## **6.6 KV VACUUM CONTACTOR PROPBLEM**

**28-12-2005**

**G Blast Furnace**

## 6.6 KV VACUUM CONTACTOR PROBLEM IN 'G' BLAST FURNACE

AREVA solution for mech trip

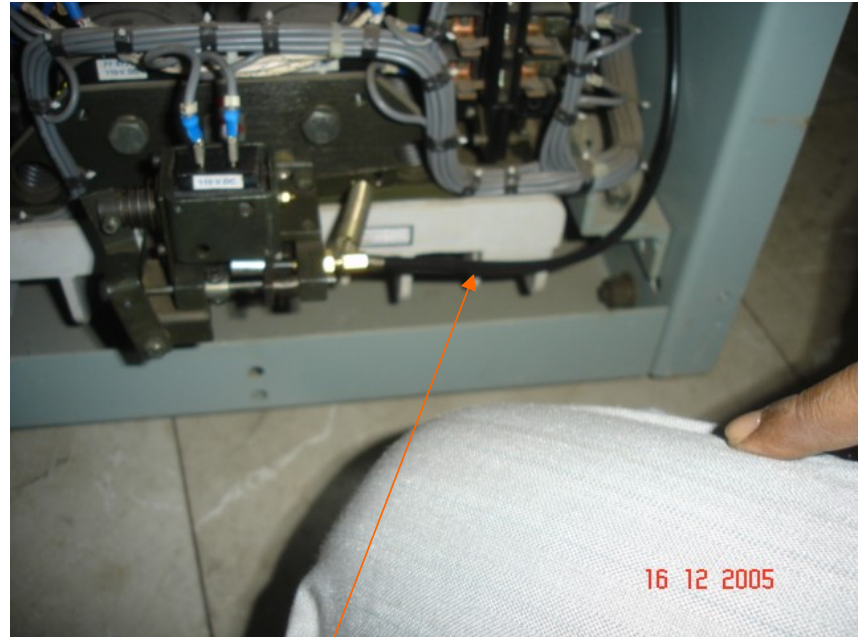
Date	Time	Detailed Observation	Action Taken
16-12-2005	11:00 am	It was observed that Vacuum contactor can put inside in closed condition also if people put off control power for safety reason during insertion. Mechanical trip facility is must to avoid this practice.	Mr Raghavulu , Mr D K Singh ( Spl project) Mr Mohanty ( L & T) and Mr Sajeev ( DUSTOR Co) are informed and ask to take action regarding this problem.

Round rod and grub screw

Coil 110 V DC

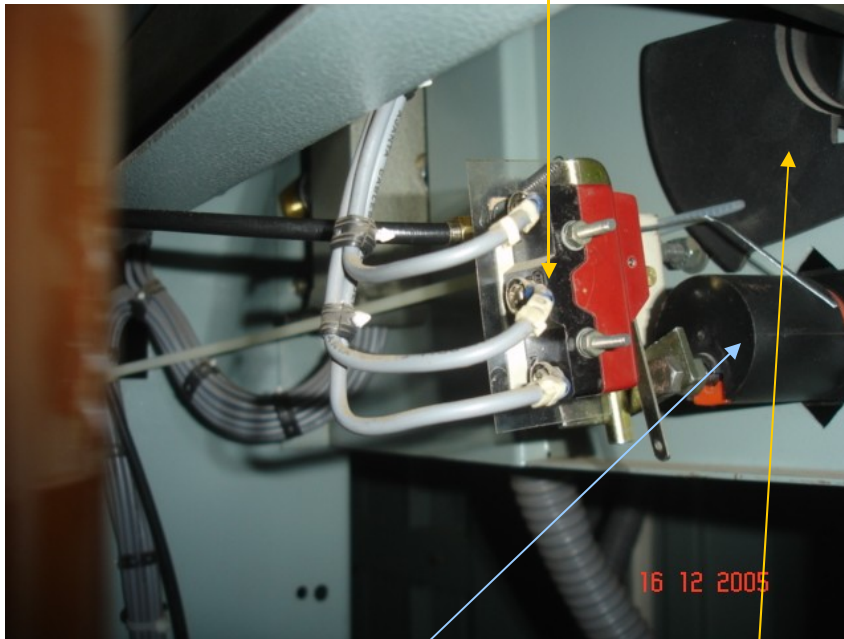
TATA steel pointed out that loosening of striker metal ring from its position was the main reason for not tripping the contactor and burning of trip coil. It was observed that the guide rod on which this metal ring is mounted is too thin (Approx. 3mm) and round, hence the striker ring got loosened due to vibration after several operation.

The mechanical trip handle provided on the panel is fouling with the cable and also the handle is not properly adjusted to trip in case of emergency. Areva agreed to set right the mechanism. Areva will submit the schedule for completing the above jobs to TATA steel within one week.

Electrical s/w available instead of mechanical trip mechanism.

Trip actuator

Lock/Free s/w for VC in/out should trip VC mechanically ( Standard safety Features)

AREVA agreed to make necessary modification with permanent locking mechanism so that it does not loose after repeated operation.
